## North Coast Regional Water Quality Control Board

Subject: **Notice of Violation for Failure to Comply with Cleanup and Abatement Order No. R1-2019-0051 (CAO) Required Actions Nos. 4 and 8**

**Inspection Report for March 1, 2021 Consent Inspection,  
Humboldt County Assessor's Parcel Numbers (APNs) 223-074-004-000,  
223-074-006-000, and 223-074-009-000 (the "Property")**

Figure 1: Inspection Map from page 54 of 2021 CRMP.

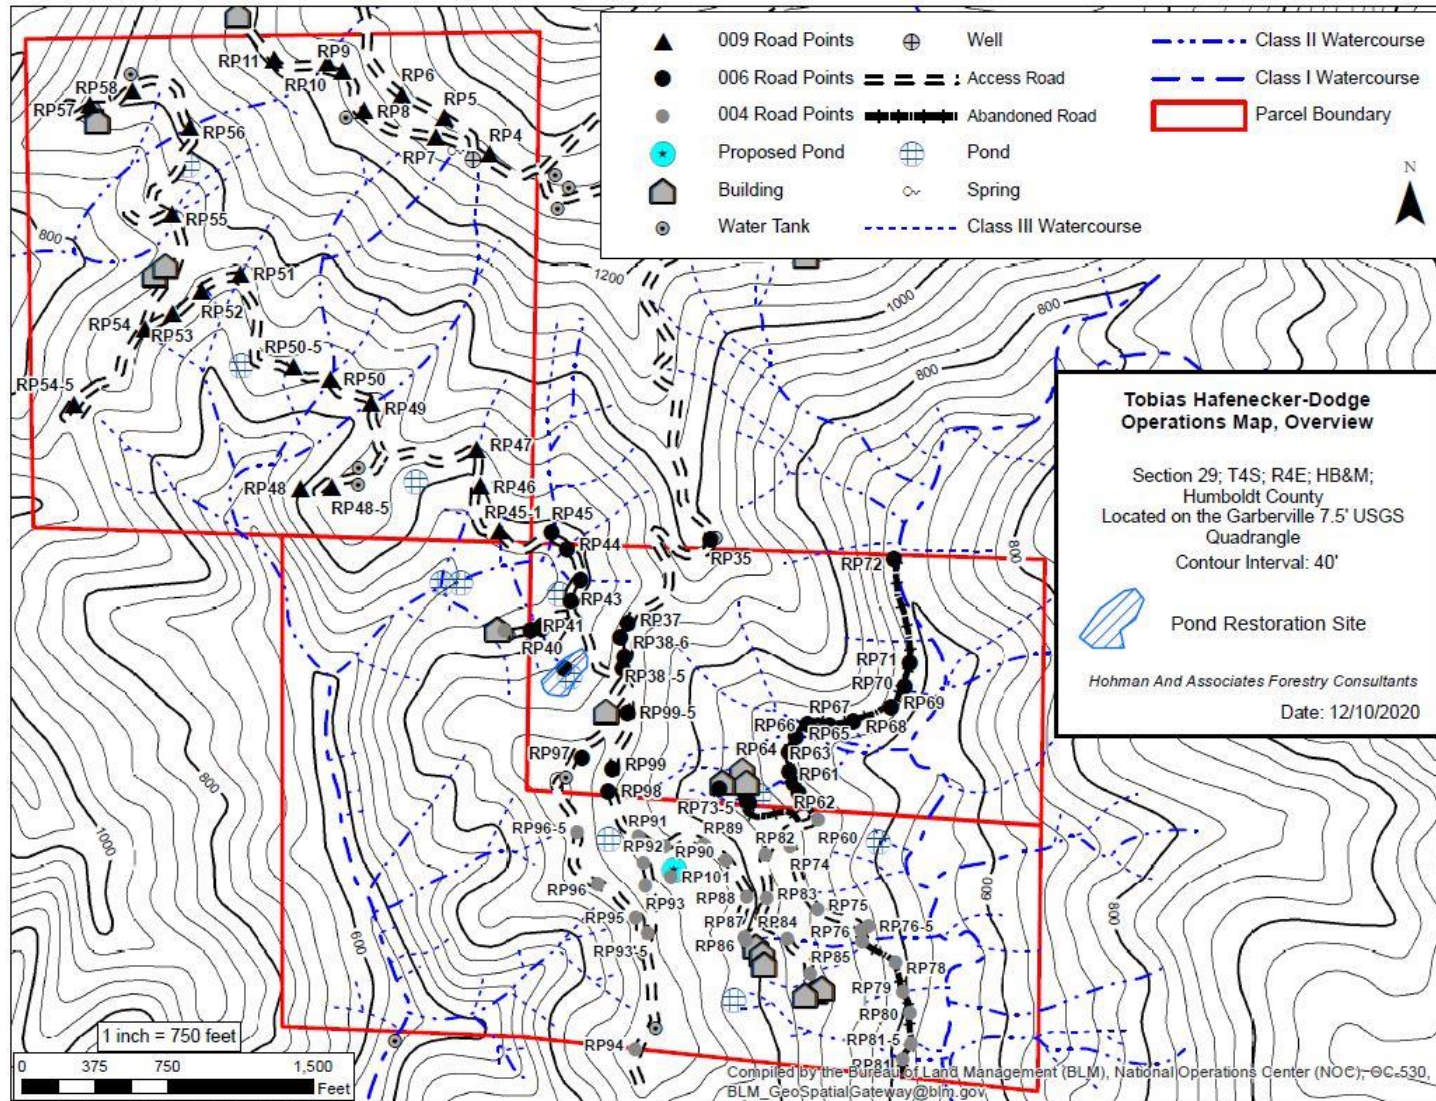
From the Glass House, we drove to the southern side of the reservoir west of RP 38-5 (Photo 12). I commented that the 2021 CRMP included only a concept drawing for the reservoir restoration on one page (Figure 2) of an eleven-page drawing set which focused on the construction of a new reservoir elsewhere on the property. I explained that the CAO does not require the Dischargers construct a new reservoir but does require remediation of the current reservoir location. I noted the sketch in Figure 2 proposed constructing a channel connecting stormwater runoff from the parking area south of the reservoir to Panther Canyon to the north. I recommended that the Dischargers consider constructing a vegetated area to diffuse the stormwater instead of connecting it directly to receiving waters. I commented that the Aquatic Resources Report, beginning on page 119 in the CRMP, identified a possible 0.15 acres of aquatic features in the area. I explained that I expected the CRMP to propose recreating these features.

3. Provide in a revised CRMP a full plan for restoring the Reservoir area including: a grading plan showing how much earth will be moved and to where, and a drawing showing locations for restored aquatic features. The plan should also include a planting plan with species list and distribution for suspected wetlands and areas riparian to recreated stream channels.
4. Include in a revised CRMP a complete assessment of the unauthorized impacts at the enlarged pad at the Burned Area (RP 98).
5. Revise the proposed treatments at RP 91, RP 86, RP 87, RP 85, and RP 84 in accordance with what we discussed during the inspection (as summarized above).
6. Develop a plan for containing refuse at RP 85.
7. Provide additional detail, as discussed in Road Decommissioning, above, as part of the mitigation proposal for the CRMP.
